MANUAL IDENTIFICATION

Model Number: 8445B

Date Printed: May 1973

Part Number: 08445-90103

Figure 1. Partial Schematic of Figure 8-10

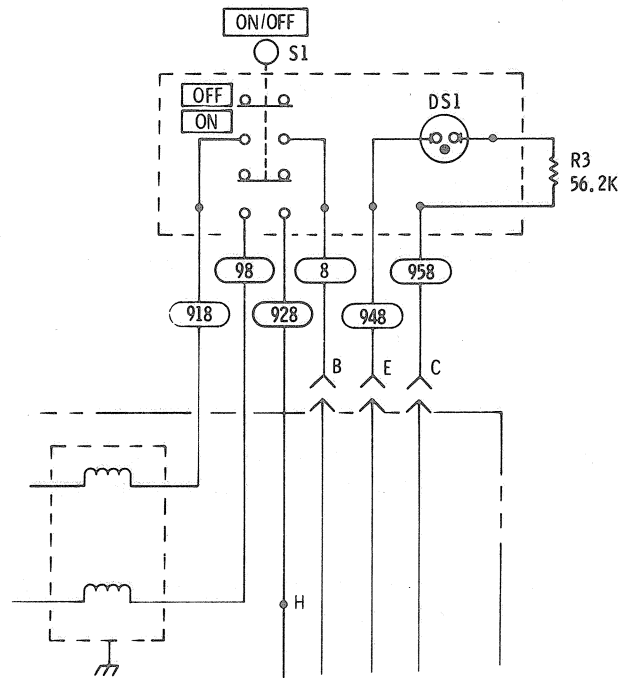
Page 8-23, Figure 8-10 (Service Sheet 6):

Change the diagram as shown in the partial schematic of Figure 1.

Figure 2. Partial Schematic of Figure 8-9. (P/O Change 1)

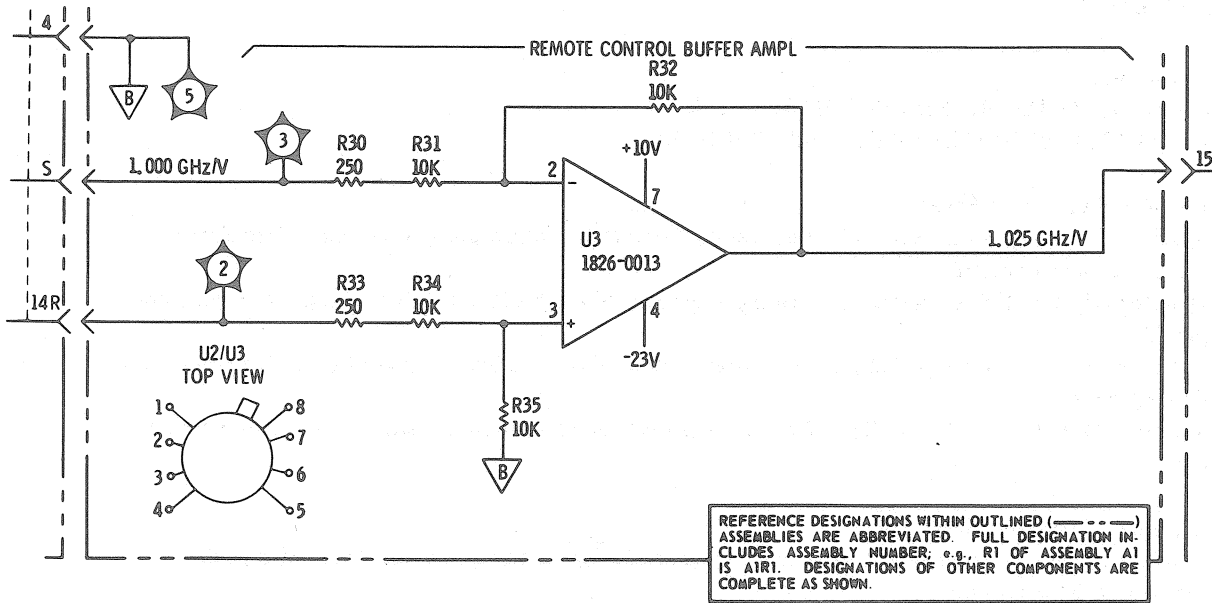
Page 8-9, Figure 8-21 (Service Sheet 5):

Change the circuit diagram as shown in the partial schematic Figure 2.

Figure 3. Partial Schematic of Figure 8-8. (P/O Change 2)

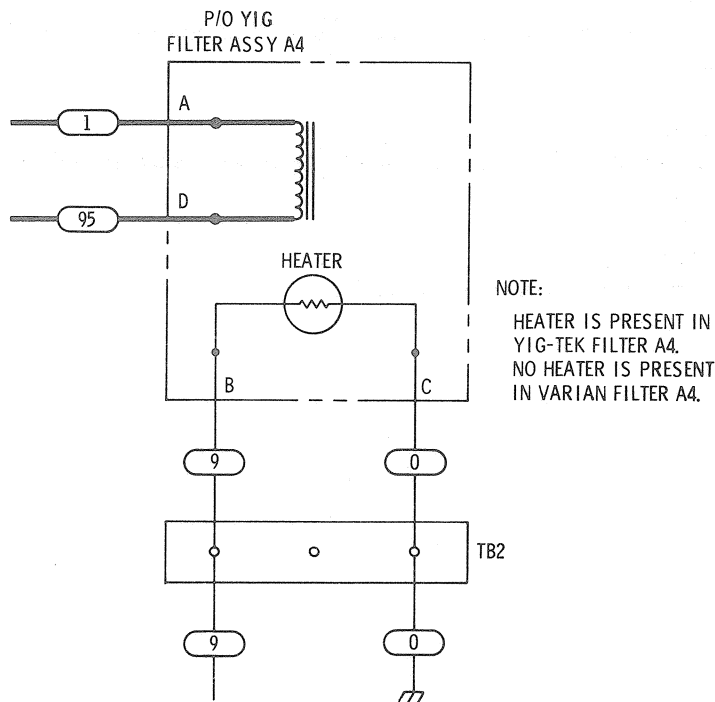
Page 8-19, Figure 8-8 (Service Sheet 4)

Add terminal strip TB2 as shown in partial schematic Figure 3.

Figure 4. Partial Schematic of Figure 8-10. (P/O Change 5)

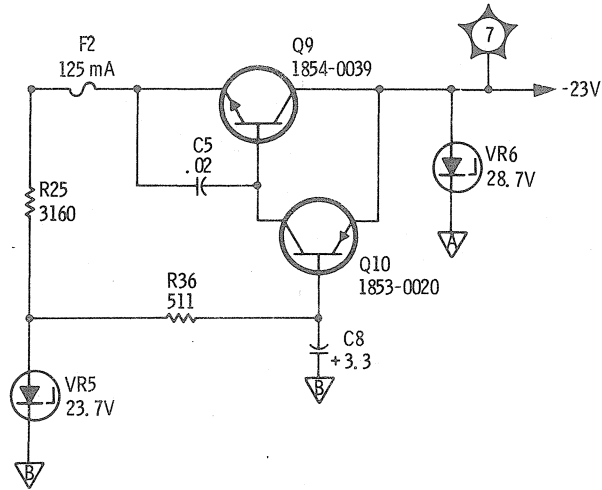
Page 8-23, Figure 8-10, Service Sheet 6:

Add A2R36 and A2C8 as shown in partial schematic Figure 4.
